**Re: Lot 16 Block 6 Unit 18 Volcano Cliffs, S.A.D. 228
6512 Kimmick Rd NW
Request Permanent C.O. – Not Accepted
Engineer's Stamp dated: 9-24-17 (D10D003M16)
Certification dated: Not Provided**

LOT 16, BLOCK 6, UNIT 18
VOLCANO CLIFFS SUBDIVISION

MICHAEL SANCHEZ - CRUZ & BRENDA - GRADING & DRAINAGE PLAN

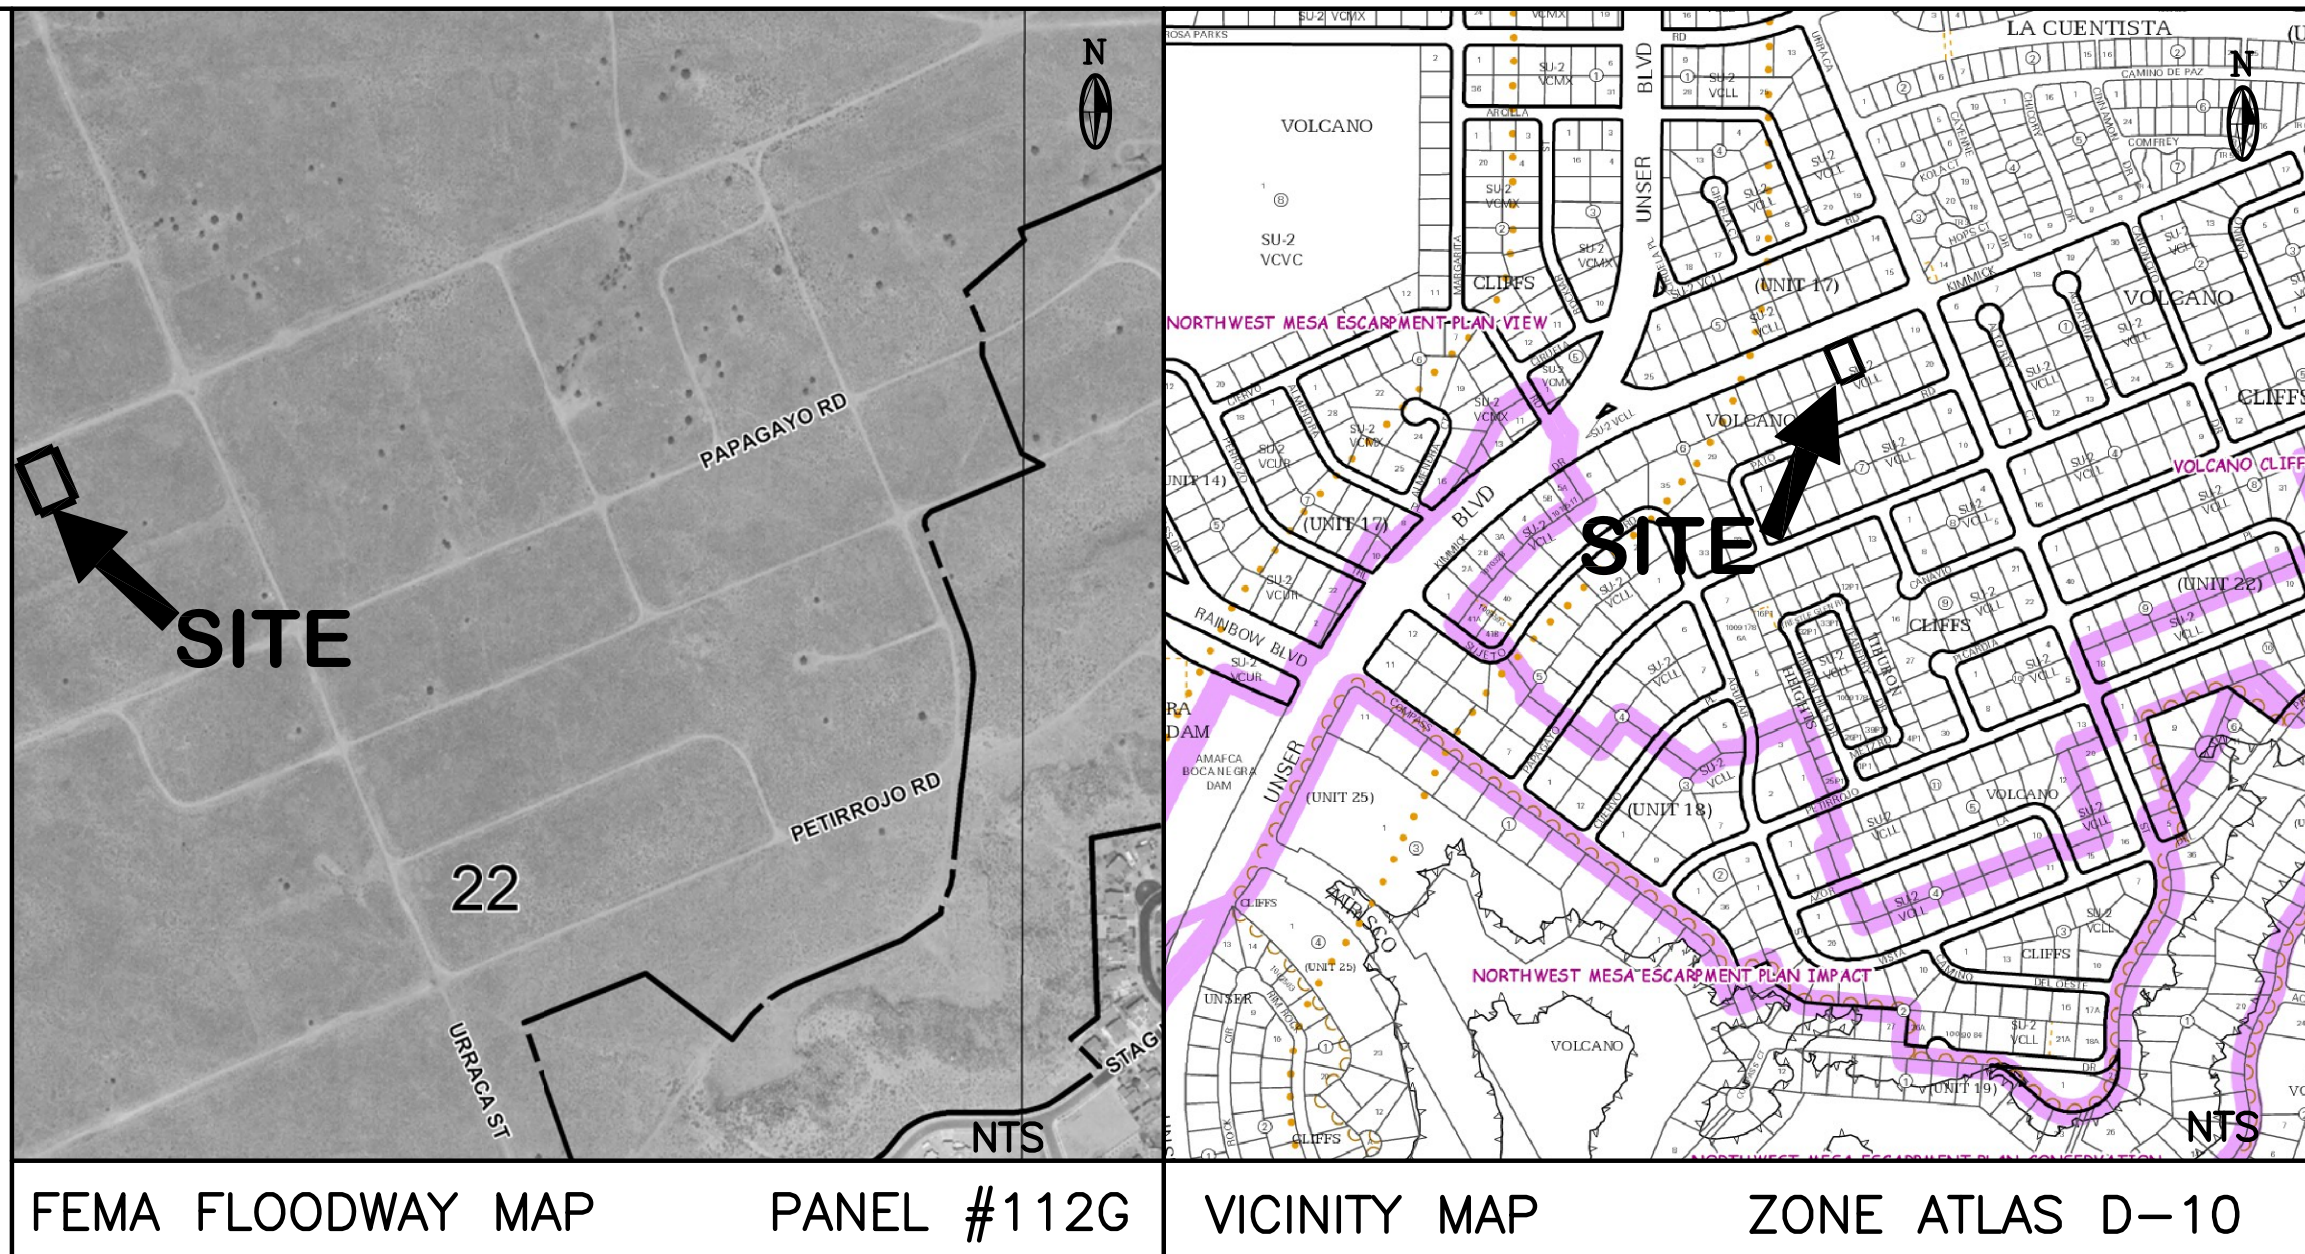
- Provide the Certificate of Occupancy statement on the plan.
